Re: FortisBC Inc. (FBC)

**2021 Long-Term Electric Resource Plan (LTERP) and Long-Term Demand-Side
Management Plan (LT DSM Plan) (Application) – Project No. 1599244
FBC Reply Argument**

**2021 LONG-TERM ELECTRIC RESOURCE PLAN AND LONG-TERM
DEMAND-SIDE MANAGEMENT PLAN**

REPLY ARGUMENT

Figure 11-7: Portfolios Considered for Preferred Portfolios

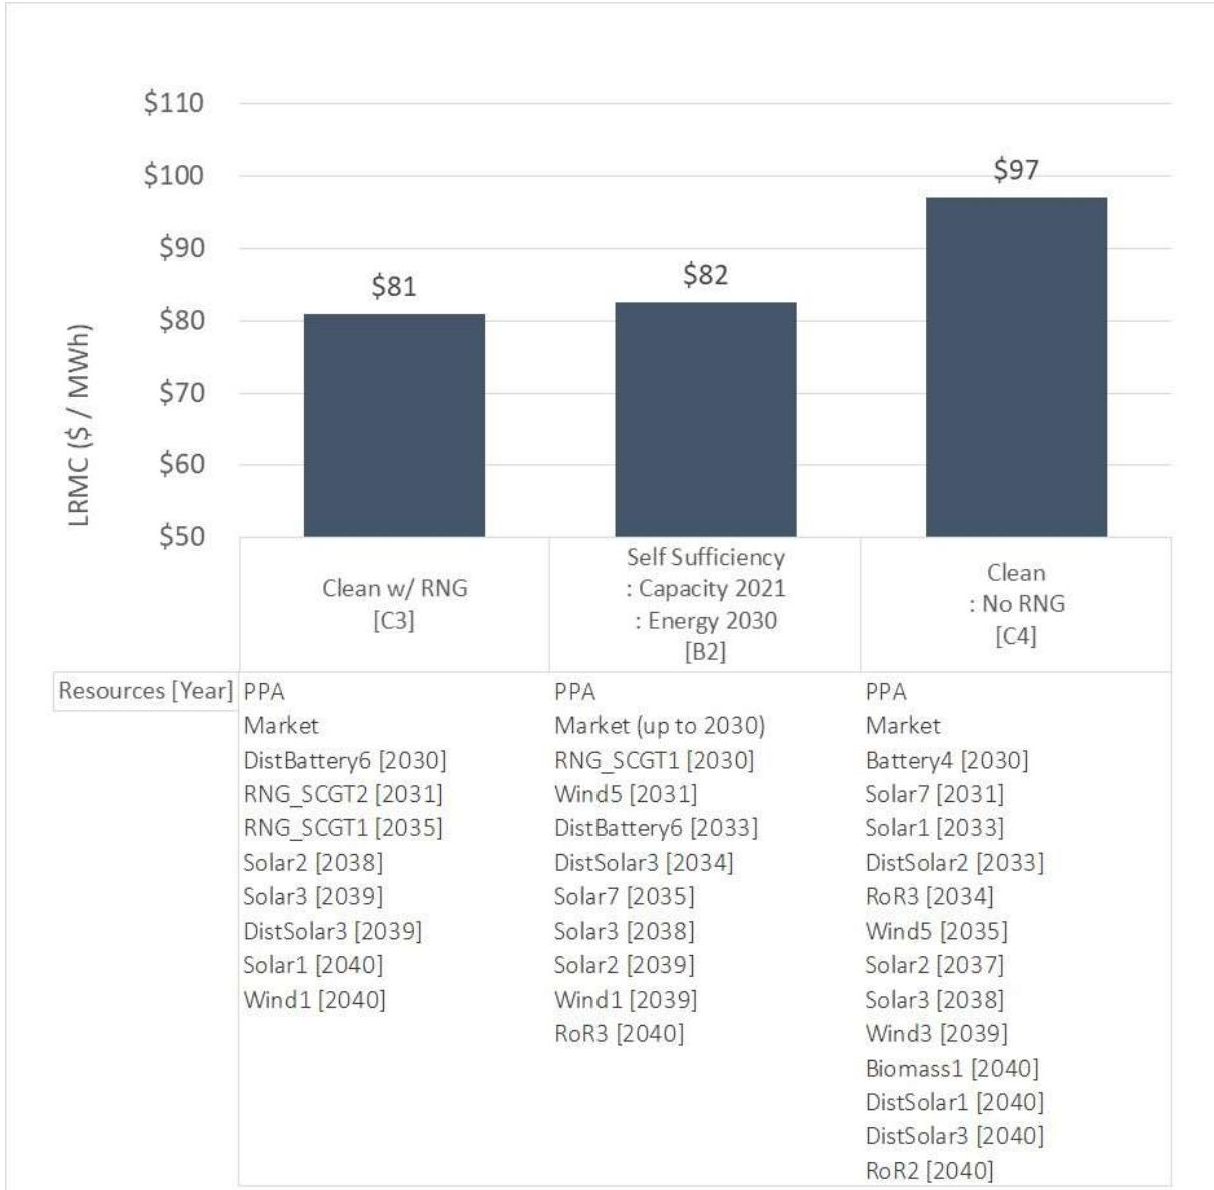
57. BCSSIA states it "is not aware of any evidence on the hearing record where the topic of a broader mix of renewable generation is discussed in any detail" and submits that this "oversight" should be addressed in the next resource plan.⁸⁰ In reply, FBC in fact considered a broad mix of renewable generation, as indicated by the Resource Options Report, which contains an extensive discussion of supply-side resource options.⁸¹ Amongst other analysis, FBC evaluated portfolios which include only clean or renewable resources against ones that are not clean and renewable, as presented in Figure 11-3 of the LTERP.⁸² Furthermore, FBC's preferred portfolios themselves include a broad mix of renewable resources, including solar and wind resources, as shown in Figure 11-7, reproduced below.⁸³

Figure 11-5: Portfolios based on Different Percentages of EV Charging Shifting

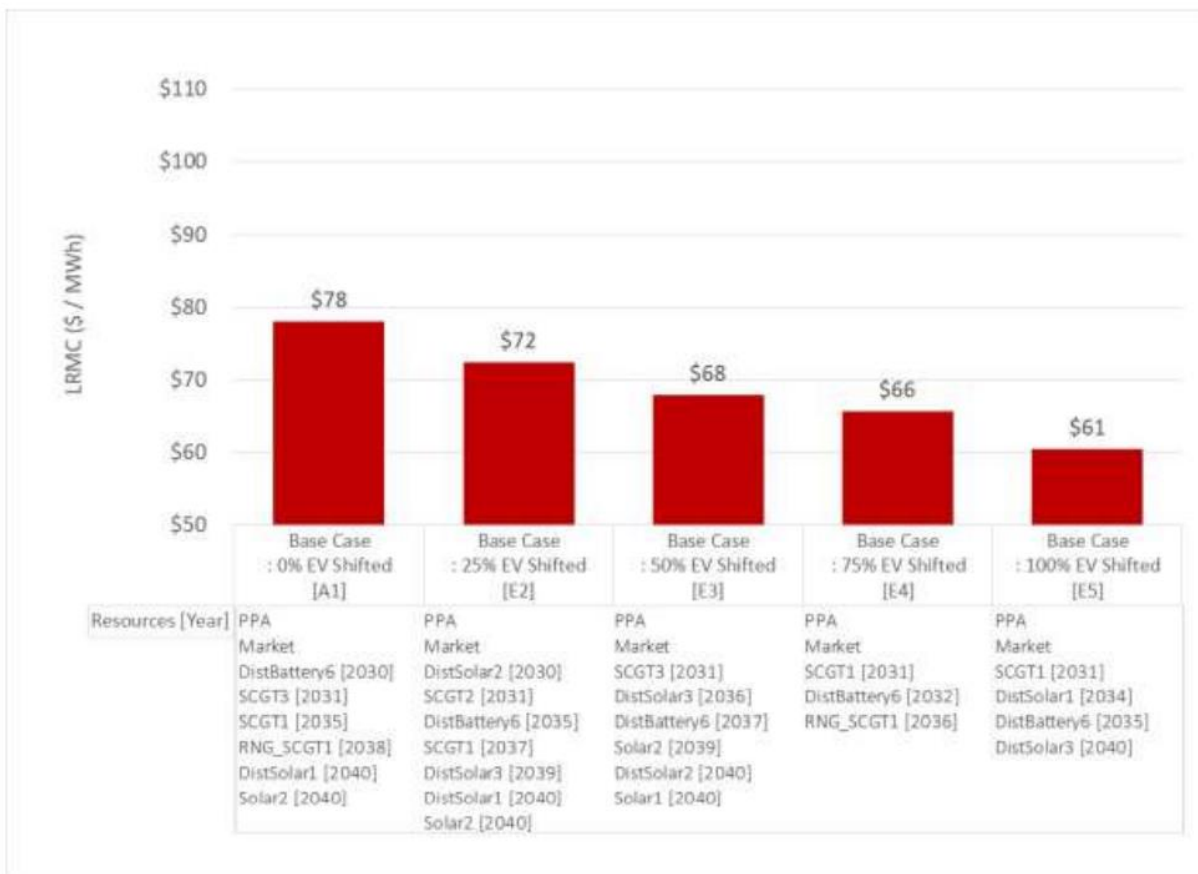
65. First, CEC's recommendation appears to be based on its statement that FBC's portfolio analysis process does not necessarily include potential programs for EV load shifting to off peak load times.⁸⁸ However, even though FBC does not yet have a program in place for EV shifting, FBC included in its portfolio analysis estimates for various portfolios under different levels of EV charging shifting to help provide some indication of the level of incremental resources and costs associated with shifting EV charging loads. This was presented in Figure 11-5 of the LTERP, which is reproduced below.
